South Texas Project Electric Generating Station 4000 Avenue F – Suite A Bay City, Texas 77414

September 28, 2009
U7-C-STP-NRC-090164

South Texas Project
Units 3 and 4
Docket Nos. 52-012 and 52-013
Response to Request for Additional Information

Question Number: 03.03-01**QUESTION:**

Figure 3.3-1 Water Use Diagram Summary

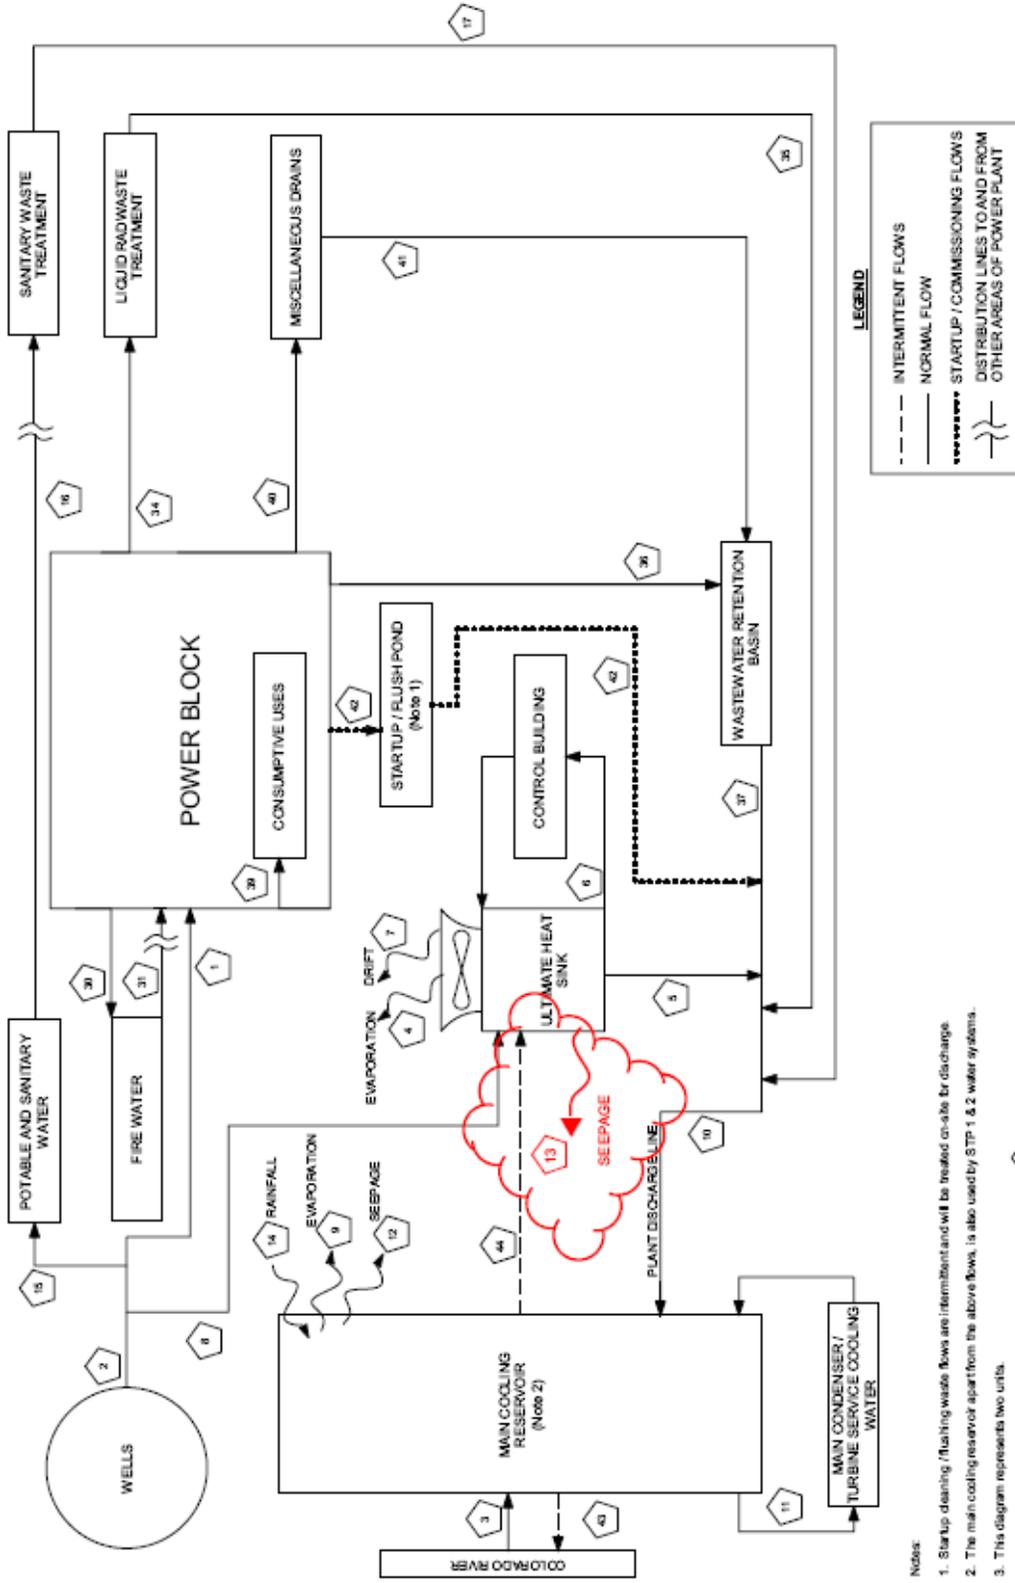
To clarify that UHS seepage is a component of the total well water demand for normal UHS System makeup (Stream 8), a new “Stream 13” will be added to ER Table 3.3-1 to represent UHS seepage. With the addition of this new table entry for UHS Seepage, the values for Streams 4, 5, 7, and 13 will correctly sum to the Stream 8 value reported in ER Table 3.3-1. A conforming change will be made concurrently to ER Figure 3.3-1, “Water Use Diagram Summary,” and Figure 3.4-1, “Cooling Water Flow Diagram,” to indicate new Stream 13 for UHS seepage.

STPNOC proposes that Figure 3.3-1 be revised to reflect new Stream 13 as indicated on the following page.

Figure 3.4-1 STP 3 & 4 Cooling Water Flow Diagram

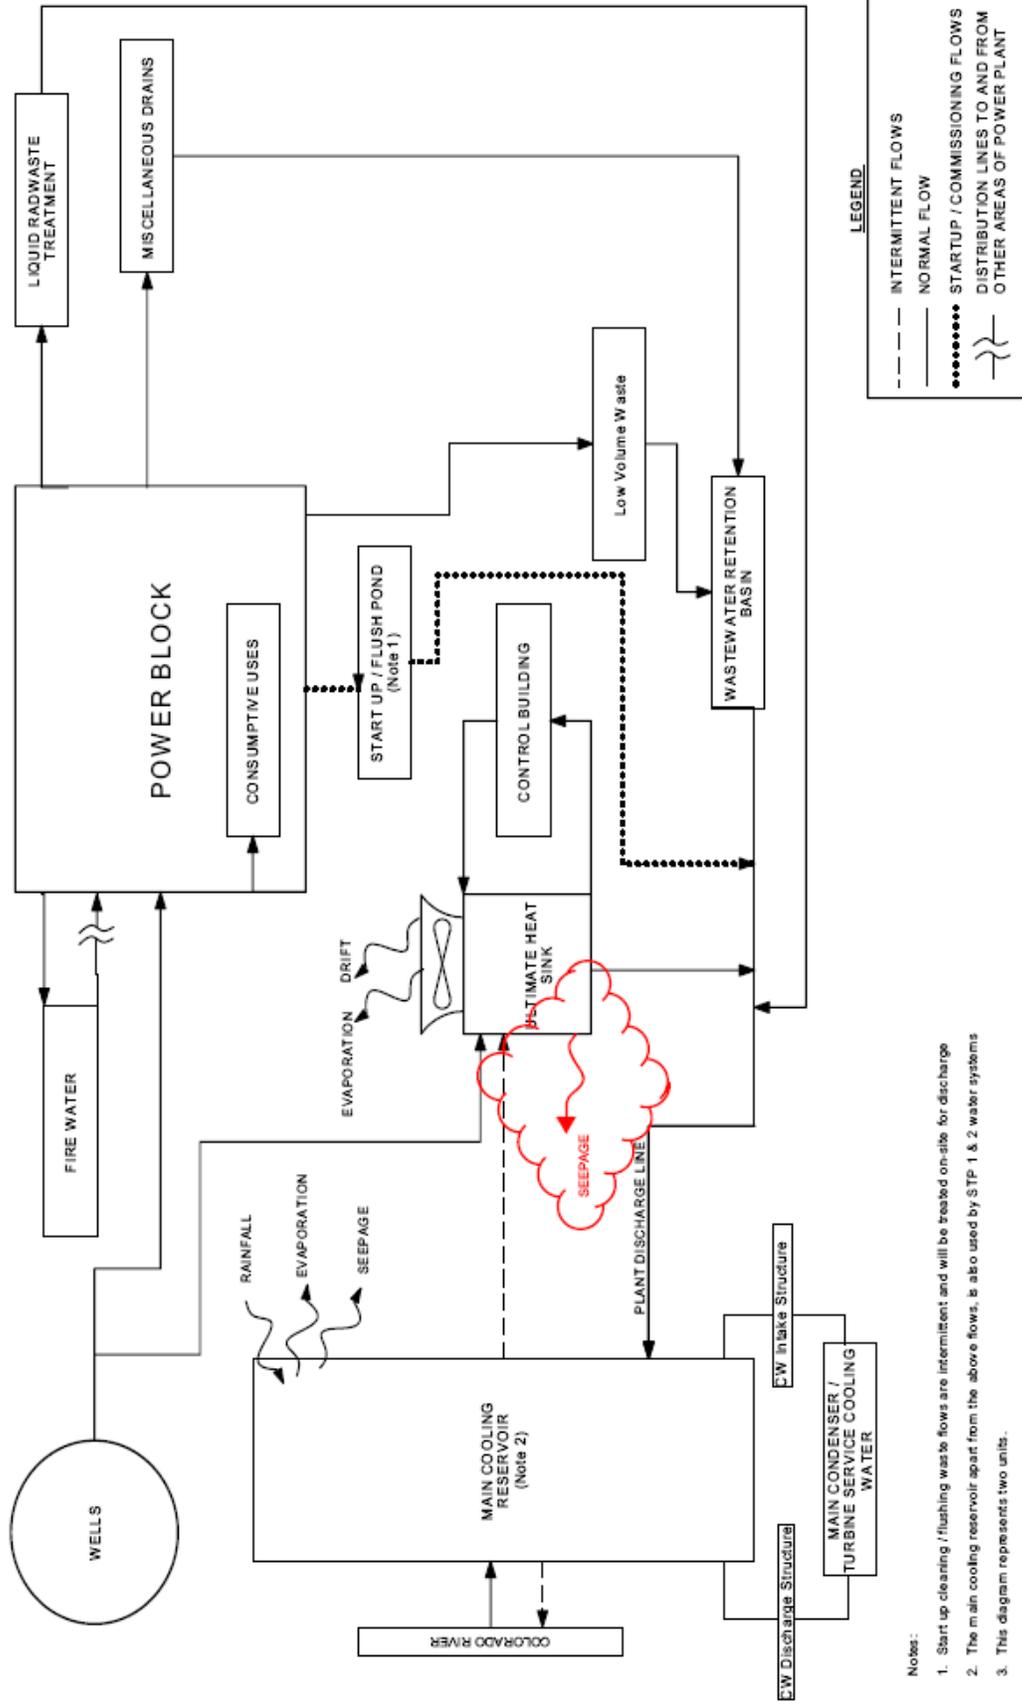
STPNOC proposes that Figure 3.4-1 be revised to reflect new Stream 13 as indicated on the last page of this response.
